# UNITED STATES PATENT AND TRADEMARK OFFICE

APPLICATION NO.	FILING DATE	FIRST NAMED INVENTOR	ATTORNEY DOCKET NO.	CONFIRMATION NO.
10/812,193	03/29/2004	Gabor w. Orosz	GO-1-gw	2861

**Office Action Summary**

Figure 2: Siebert (US 6,601,361)

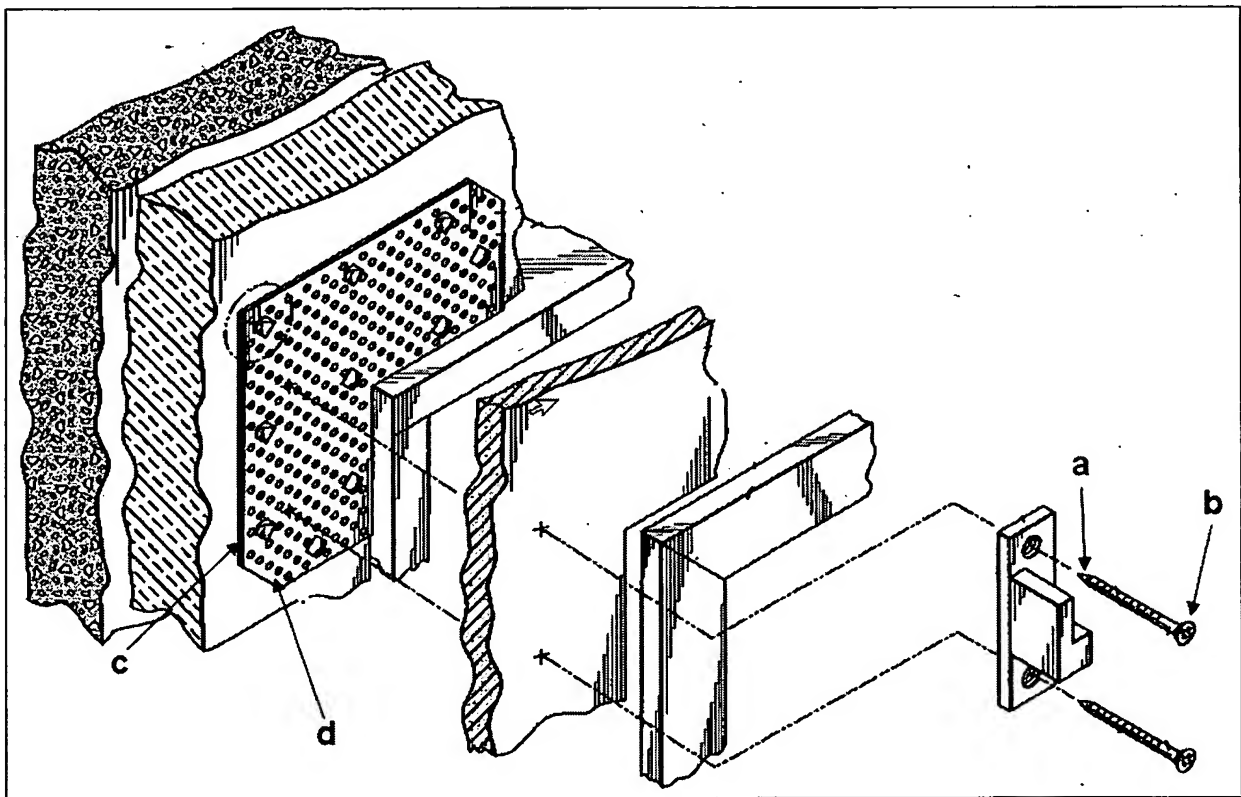
- A "platform" (12) having an upper (item d, annotated figure 2) and lower (item c, annotated figure 2) surface with a plurality of apertures (30) therein (column 4, lines 21-22). A platform upon which a user can walk is an intended use and is given no patentable weight;
- A plurality of posts (24) extending downward, where the posts are disposed in the apertures (30) on the lower surface of the "platform"

(column 4, lines 26-32). The platform being suspended on posts above the tile is an intended use and is given no patentable weight. The posts consist of a first (item a, annotated figure 2) and second (item b, annotated figure 2) end, where the second (item b, annotated figure 2) end is disposed contiguous to the "platform" (figure 3). The first end of the posts being disposed in the gaps of the tile is an intended use and is given no patentable weight. With regards to the limitation that the second end of the posts is disposed contiguous to the platform, the examiner relied upon Webster's II Dictionary 3<sup>rd</sup> ed. for the definition of contiguous, as it is not defined in the disclosure. According to Webster's II Dictionary 3<sup>rd</sup> ed., contiguous is defined as adjacent to: nearby.

With regards to claim 5, Seibert further discloses the second end of each post (24) being threaded (32) so as to interact with the threads of the apertures (figure 2 and column 4, lines 21-26).

Figure 6: Jureit (3,365,221)

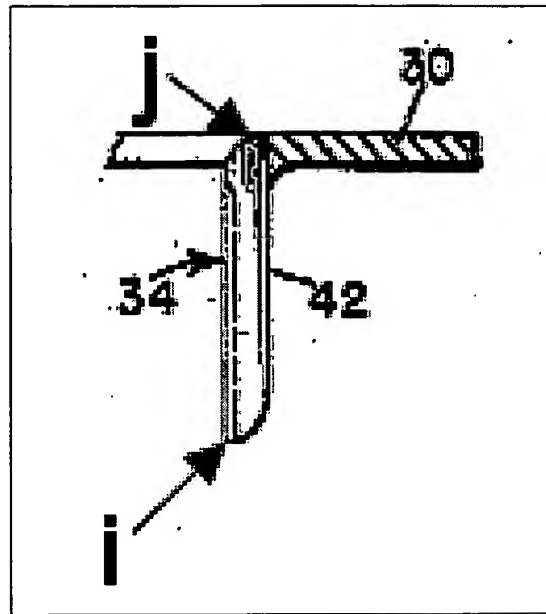
A plurality of posts (34) extending downward, where the posts(34) are disposed in the apertures (35) on the lower surface of the "platform" (30). The platform being suspended on posts above the tile is an intended use and is given no patentable weight. The posts (34) consist of a first (item i, annotated figure 6) and second (item j, annotated figure 6) end, where the second (item j, annotated figure 6) end is disposed contiguous to the "platform" (30). The first end of the posts being disposed in the gaps between the tile is an intended use and is given no patentable weight.

Figure 3: Goeman (US 4,359,849)

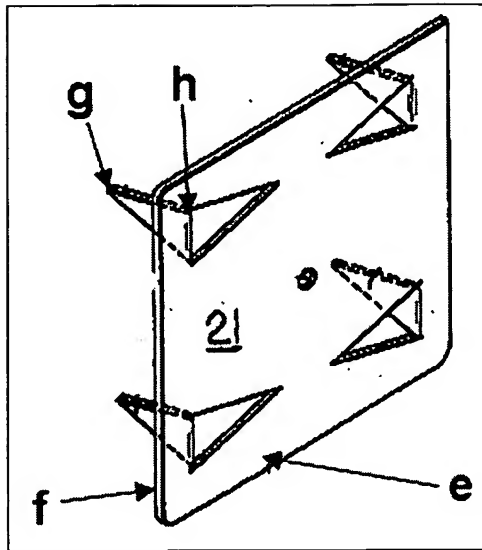
- A "platform" (20) having a lower (item f, annotated figure 3) and upper (item e, annotated figure 3) surface. A platform upon a user can walk is an intended use and is given no patentable weight;
- A plurality of pre-punched tabs (22) disposed from the surface of the "platform" (20), where the tabs (22) can be downward extending away from the lower surface to allow for the capability of the "platform" to be suspended on the tabs above the tile. The tabs have a first (item g,

annotated figure 3) and second (item h, annotated figure 3) end, where the second (item h, annotated figure 3) end of the tab (22) is disposed from the "platform" (20). The first end of the tab being positioned in the gaps between the tile is an intended use and is given no patentable weight.

With regards to claim 11, Goeman further discloses tabs (22) that are spaced apart, where tabs (22) can be selected to be bend downward (figure 3 and column 3, lines 47-51).

With regards to claim 12, Goeman further rectangular shaped "platform" (figure 3 and column 3, lines 51-54).

With regards to claim 13, Goeman further discloses tabs (22) that disposed on the corners of the rectangular shaped "platform" (figure 3 and column 3, lines 51-54).
